CITY OF ALBUQUERQUE

Planning Department
Alan Varela, Director

Re: Mick Rich Construction Warehouse
8401 Firestone Lane NE
30-Day Temporary Certificate of Occupancy
Transportation Development Final Inspection
Architect's Stamp dated 11-07-23 (C17-D013B3)
Certification dated 05-07-2025
Trans-2025-00124

FIGURE 7.4.115 Bicycle Parking Stall Layout Options

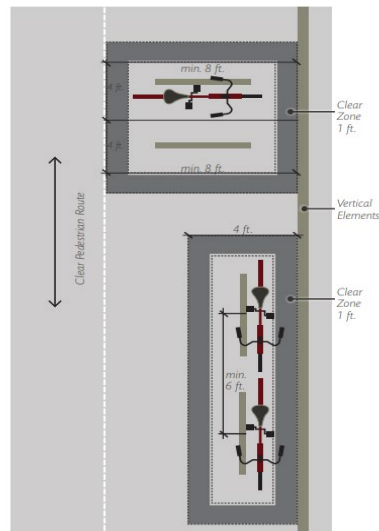
1. The construction of the site must be completed.
2. Per approved site plan and city requirement, please install the "U" shape Bike rack following the required dimensions. The wave shape bike rack is no more permitted for new sites.

1 SITE PLAN
002 SCALE 1"=20'

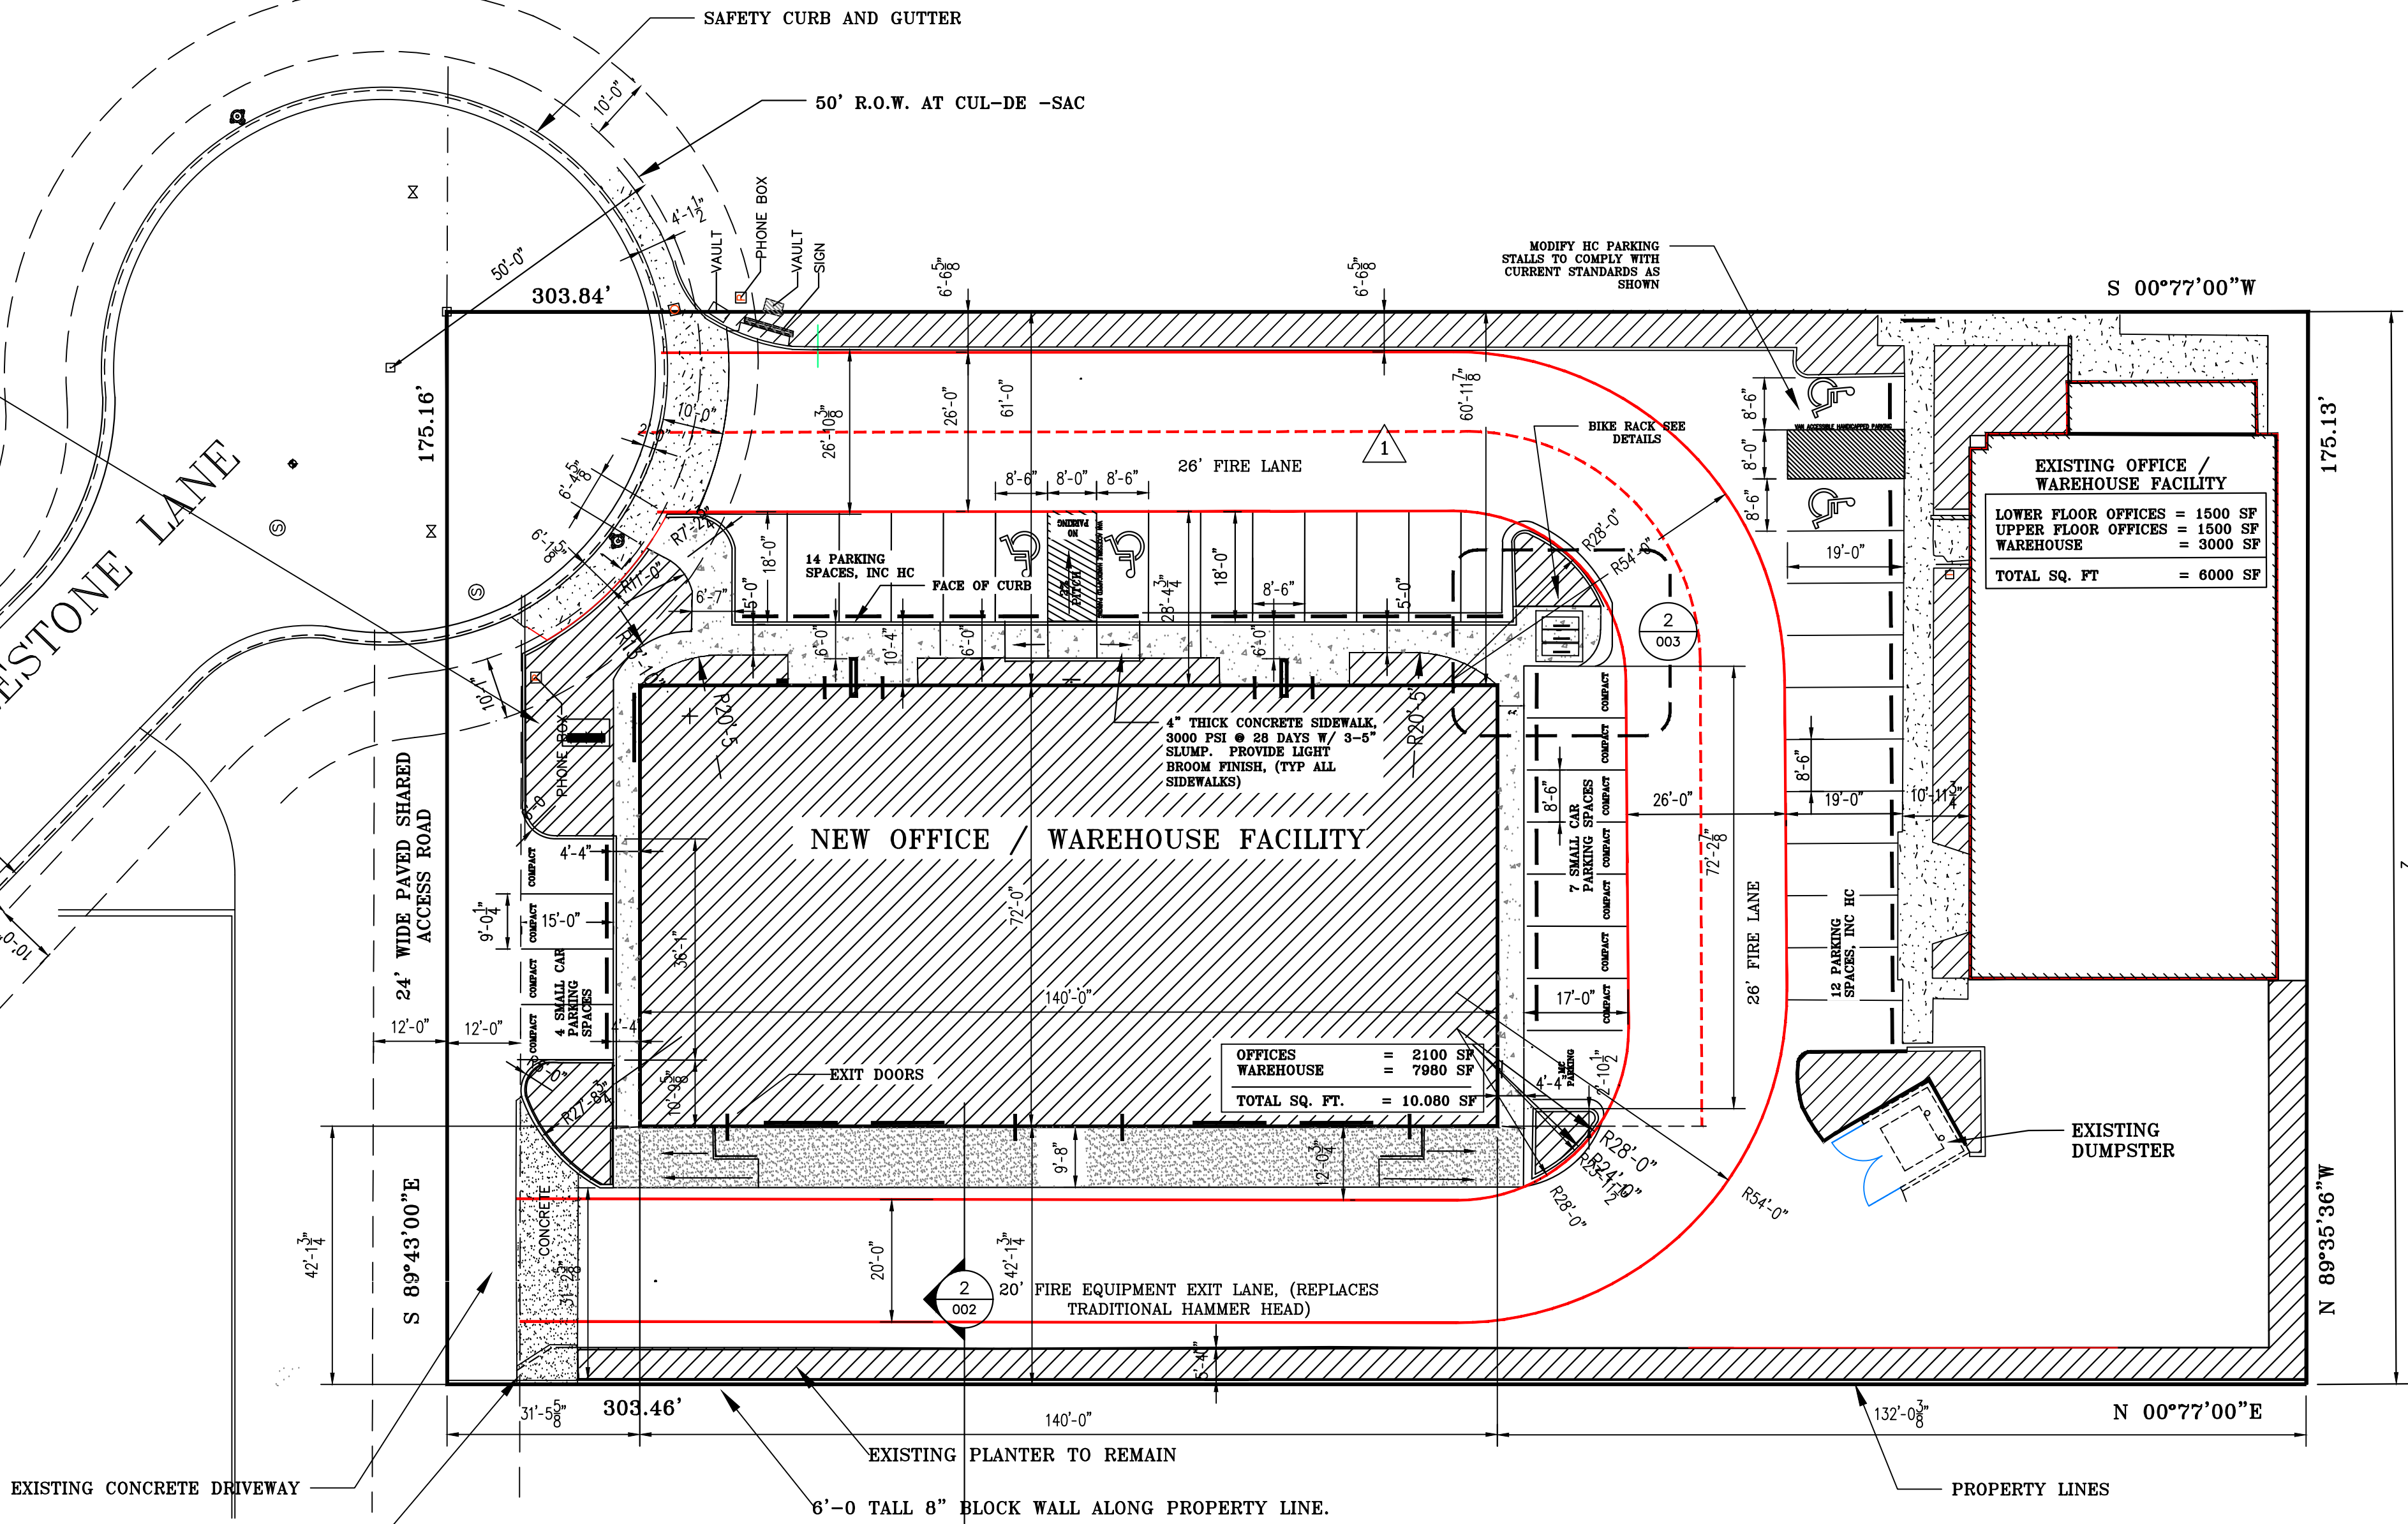
3. Due to the change of the bike rack location, Please redline the approved site to create an as built that reflects the change.
